Historic Architectural Review Commission Staff Report for Item 3

Application Number: C2025-0025

Address: 525 Southard Street

New diesel generator with pad and fence.

Existing Elevation from Southard Street.

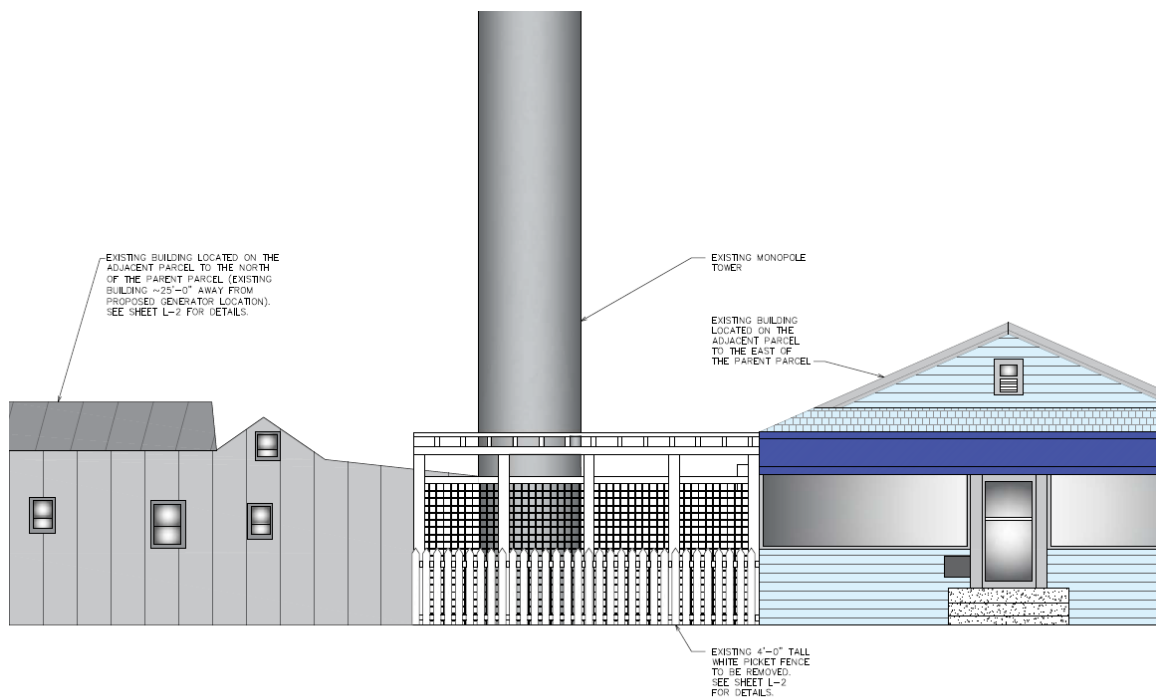
The proposed installation of a 200 kW diesel generator with a 693-gallon tank is consistent with HARC guidelines, as no work will be conducted on the principal historic structure, therefore preserving the integrity of the contributing building. The generator will be placed on a new 8' by 18' concrete pad within the equipment compound and screened from public view by an 8' tall picket fence.

Proposed Elevation from Southard Street.

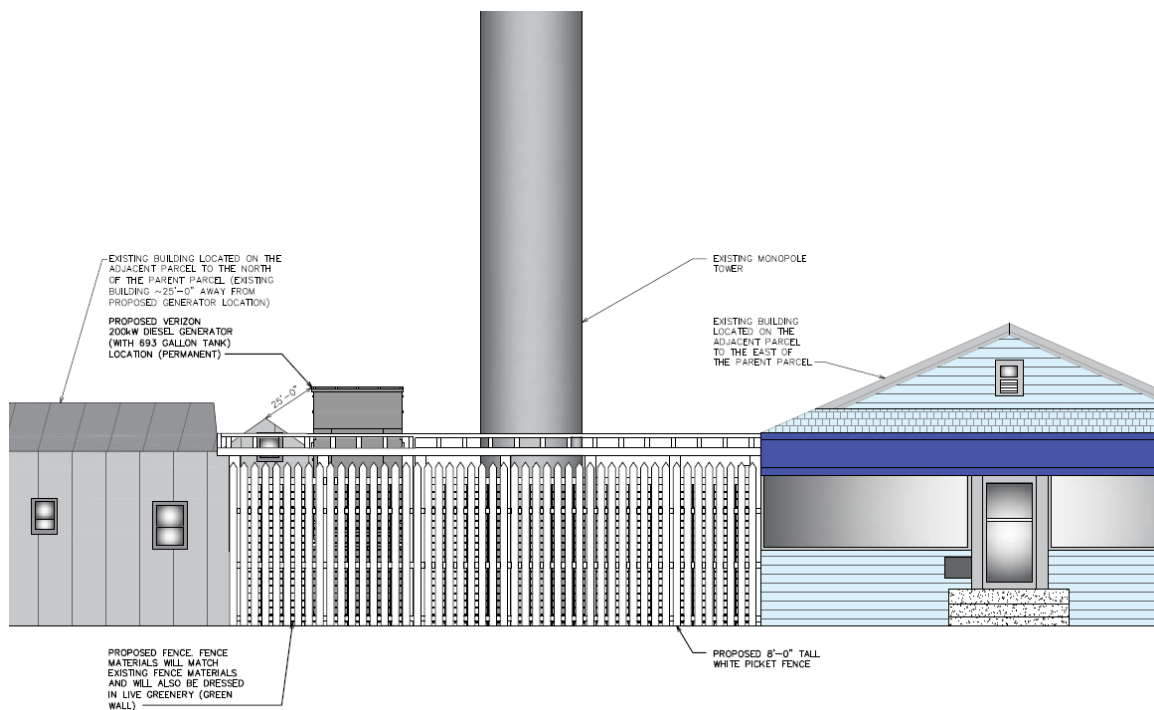
This is a unique proposal as it involves enclosing a permanent generator, which differs from standard accessory storage structures. Guideline 12 of the Accessory Structures (LDR Sec. 108-288 – Storage Areas) requires that exterior storage areas be enclosed by a solid wall or fence between six and eight feet in height, and the proposed enclosure meets this requirement. The fence is designed to match existing materials on site and will be softened with a green wall to help reduce its visual impact. While the top of the generator will extend slightly above the fence line, the use of compatible materials and added vegetation may help mitigate its visibility. The Commission may consider whether this approach is appropriate in maintaining the character of the historic property and surrounding district.
